# Updated proposal Electrical Parameters of DME (Comment 547)

January 2025 802.3dj Interim meeting

# **Review of Comment 547**

IEEE P802.3dj 200 Gb/s, 400 Gb/s, 800 Gb/s, 1.6 Tb/s Ethernet Task Force

#### Table 73–1—DME electrical characteristics

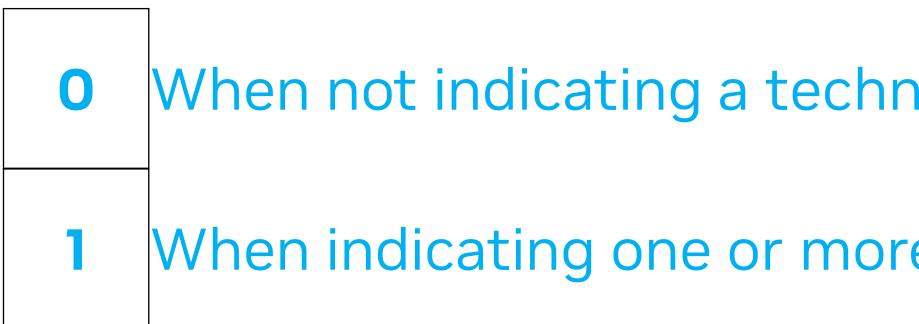
- Draft 1.3 reduced Vf from 0.6V to 0.5V for 200G/Lane devices
- - Suggestion to reduce only for 200G/Lane devices
  - Make new limit forward looking: for 200G/Lane and higher rates
- Current table shown

• Suggestion to reduce DME differential peak-to-peak output voltage from 1200mV to 1000mV to align • Out of scope due to backward compatibility (requires Maintenance to update)

• Discussion to reduce for TX only (This proposal still has both reduced for now)

• AUIs do not use transmit AN but CR and C2M share the same connector styles so interconnection between them is likely
